ADDENDUM NO. 2

**REGEN MONTEREY
MONTEREY REGIONAL WASTE MANAGEMENT DISTRICT
SCALE HOUSE RENOVATION PROJECT**

May 30, 2023

| SHEET | P203 |

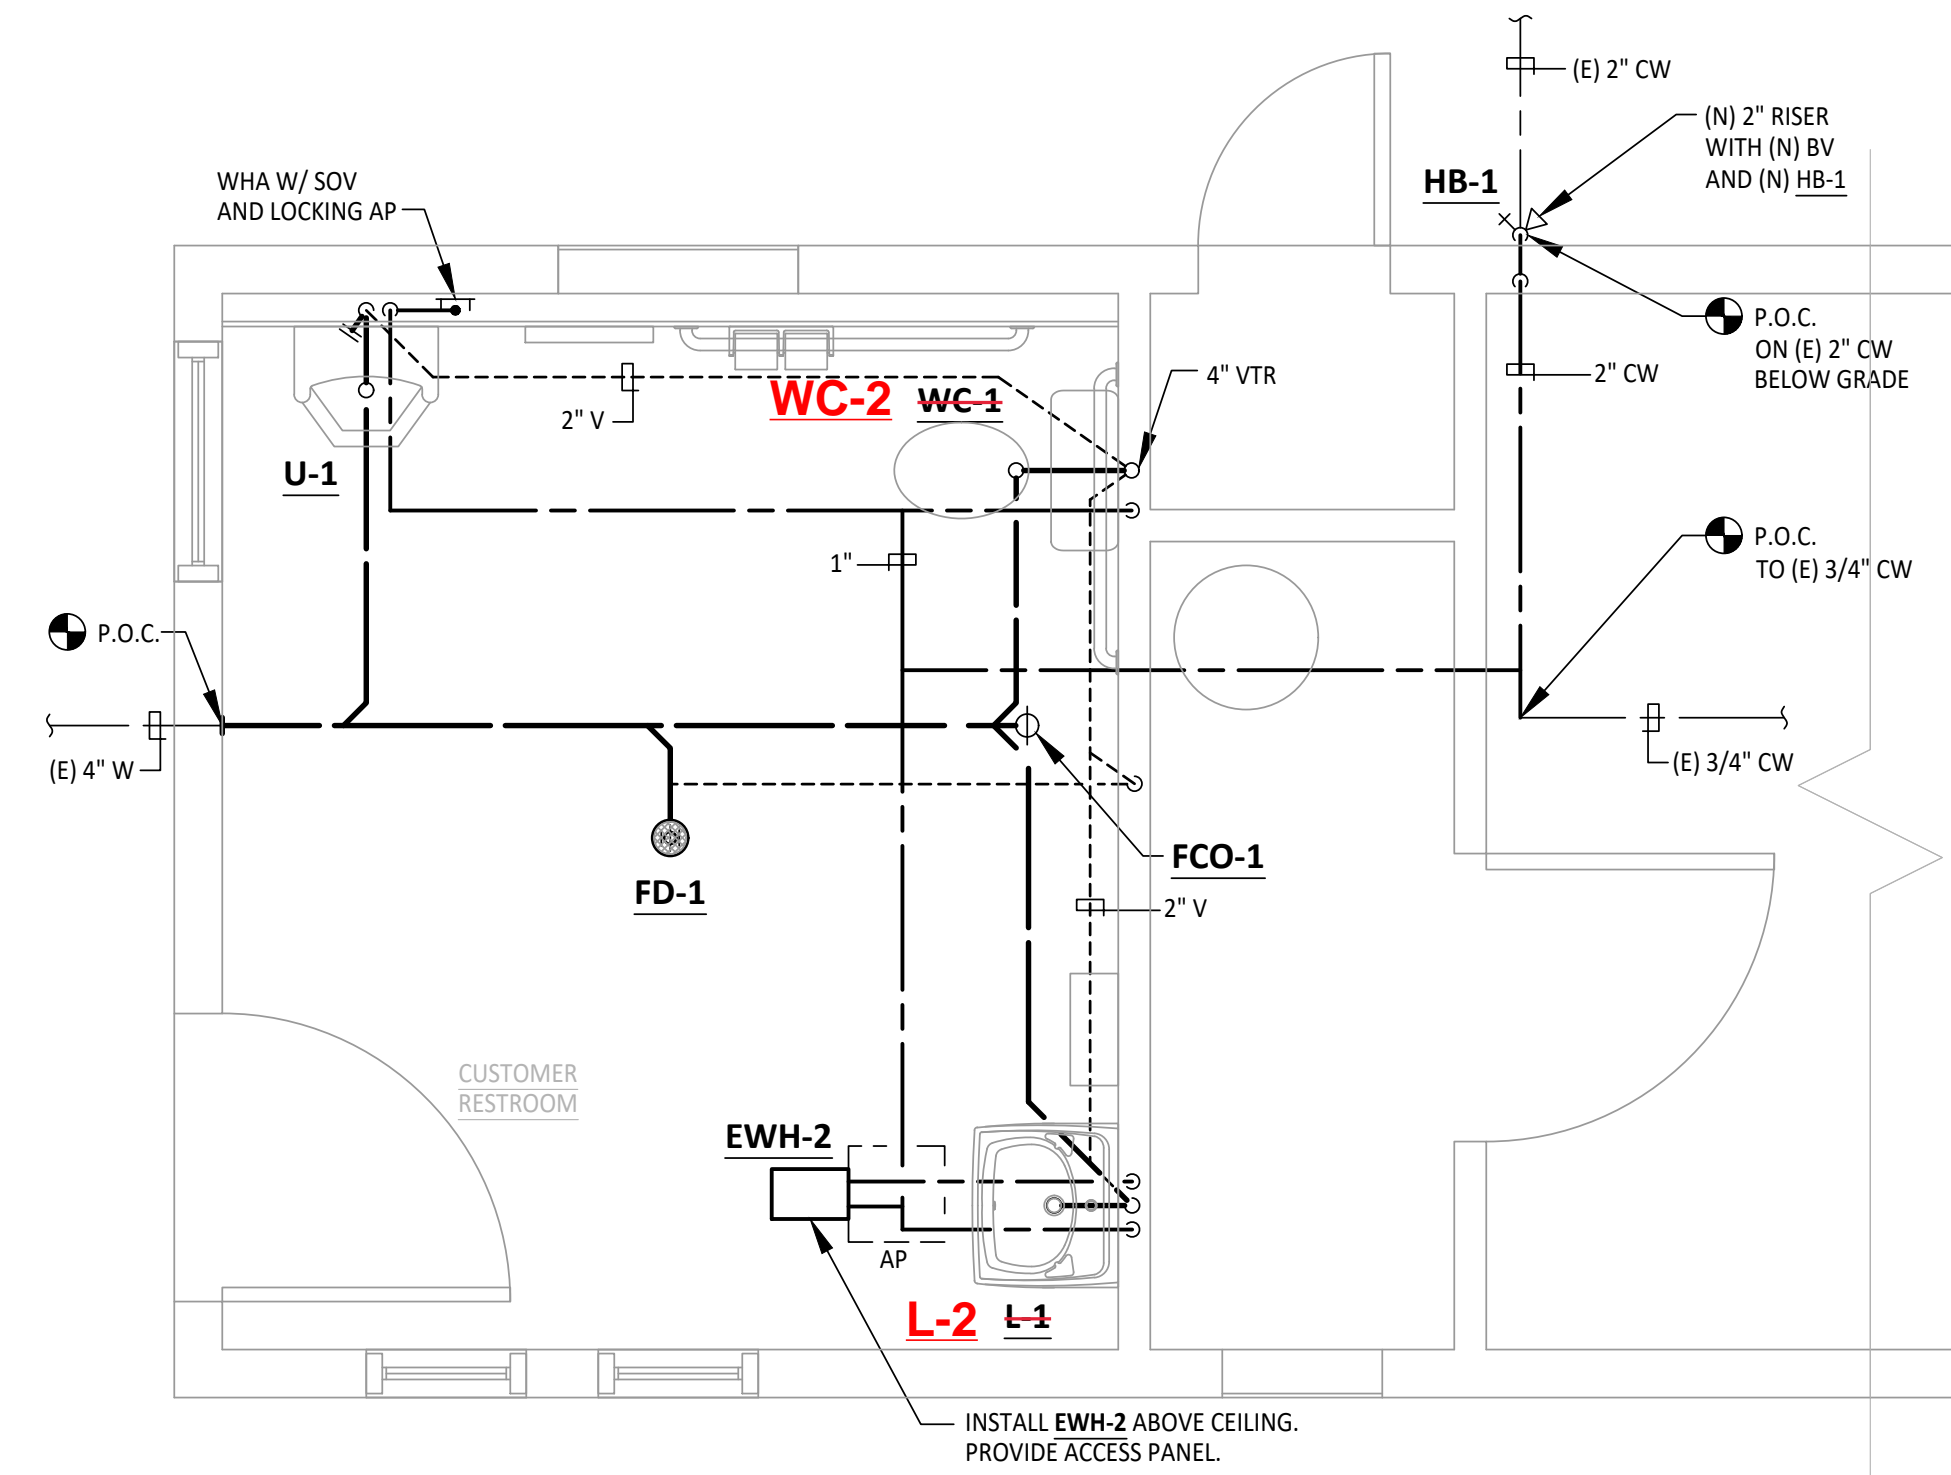
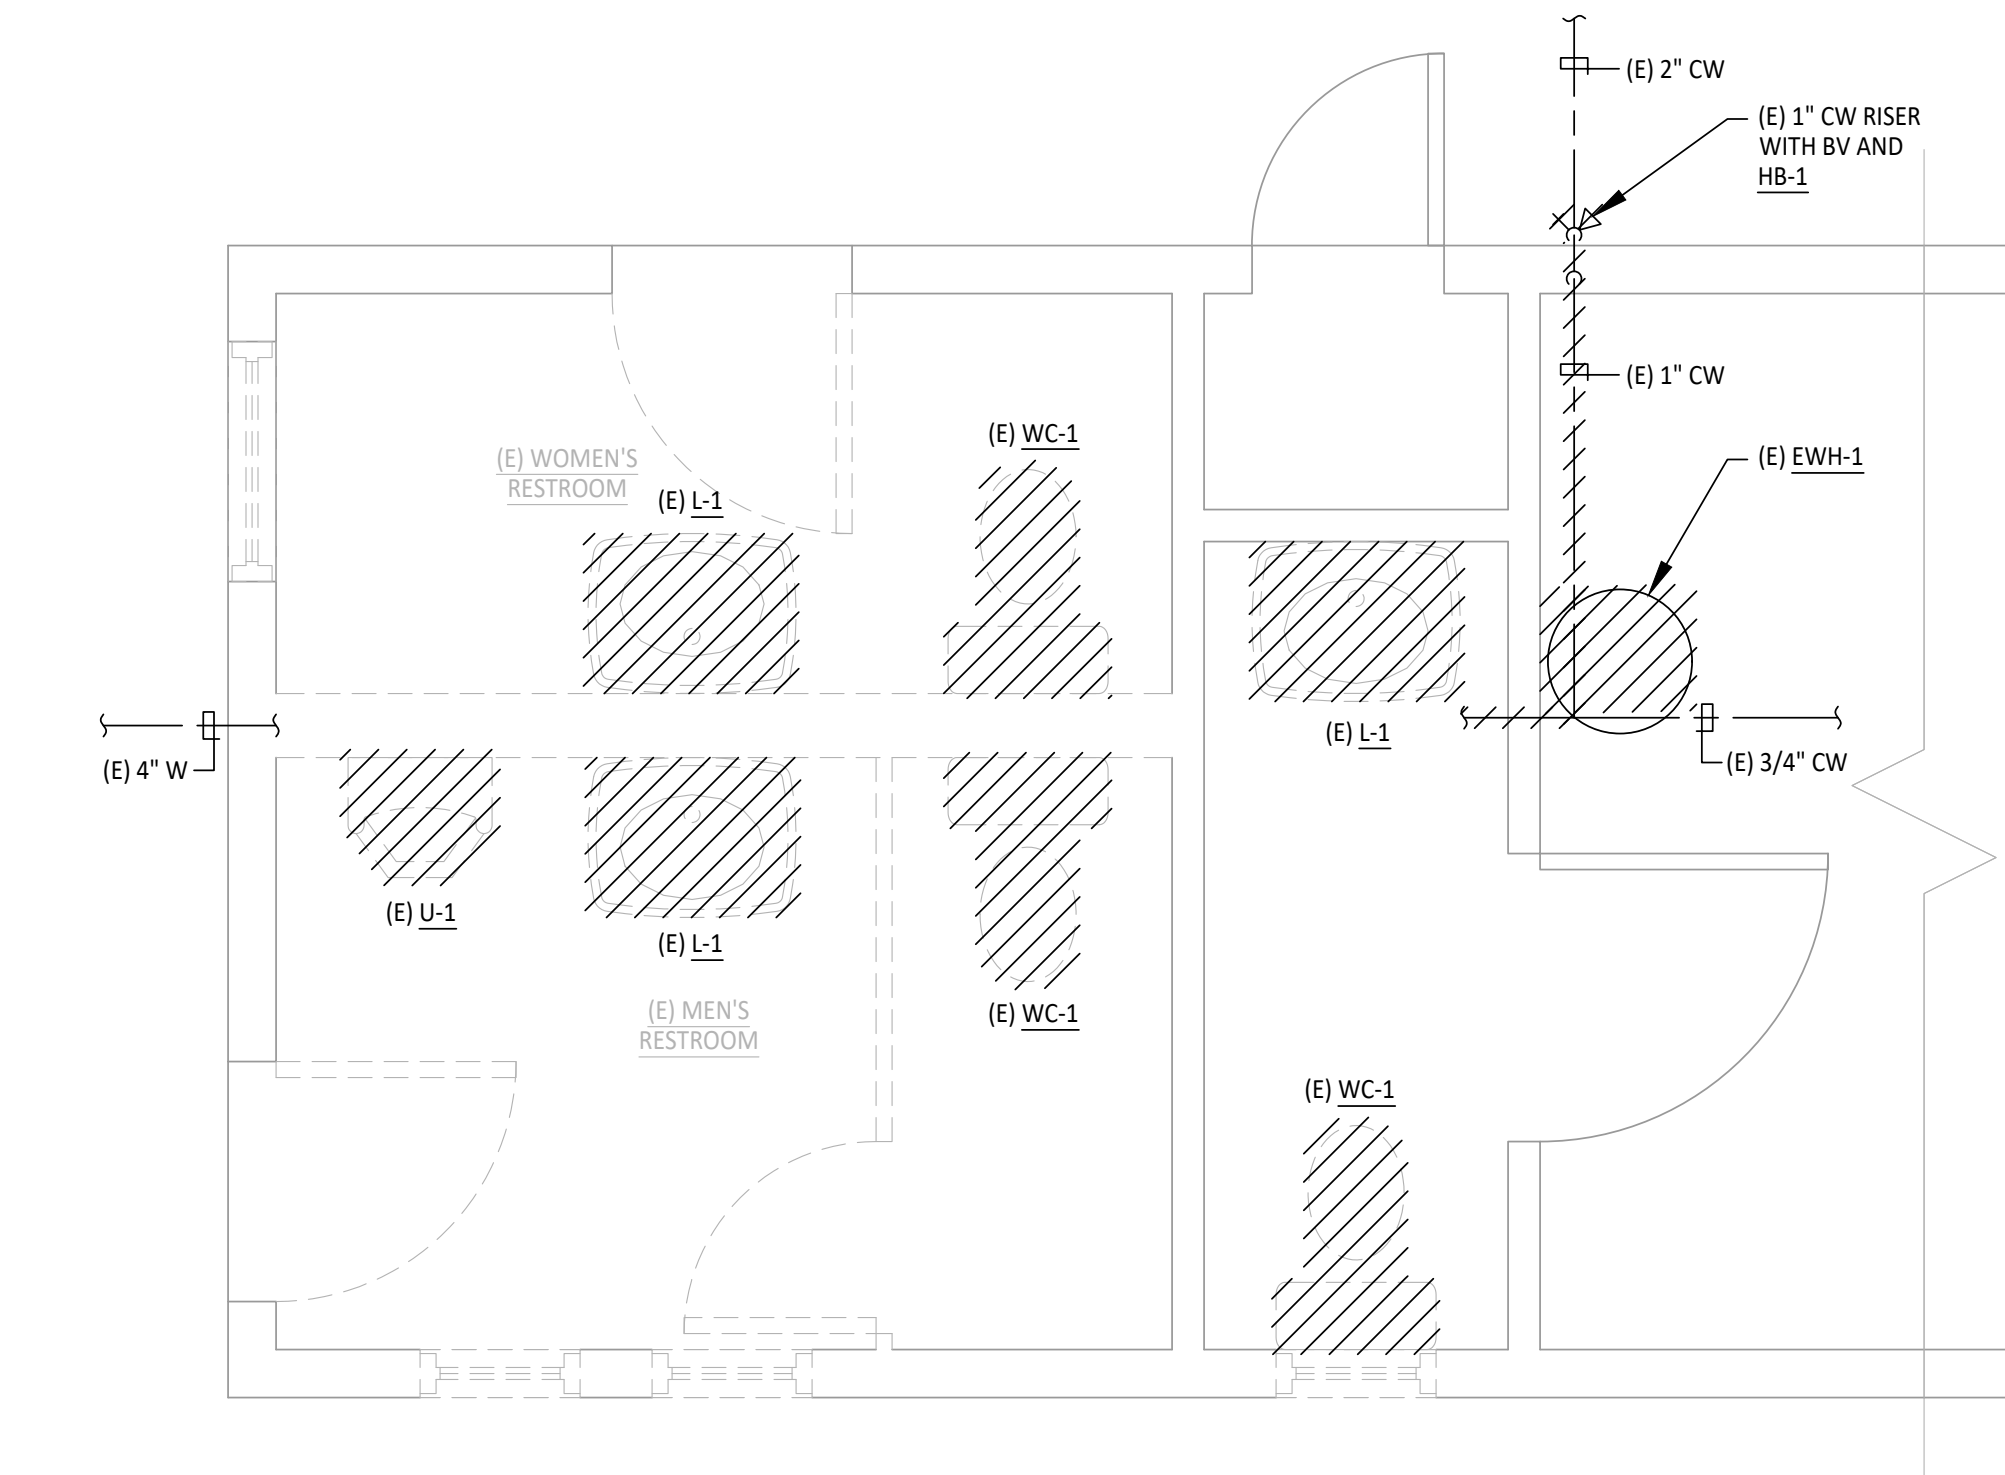
Sheet P203 shall include the following revisions:

Plumbing Fixture Callouts: L-1 and WC-1 on the Restroom Floor Plan – Plumbing shall be revised to L-2 and WC-2 respectively as shown on the attached revised sheets. All fixtures in the Customer Restroom shall be stainless steel, as listed in the Plumbing Fixture Specifications, sheet P001.
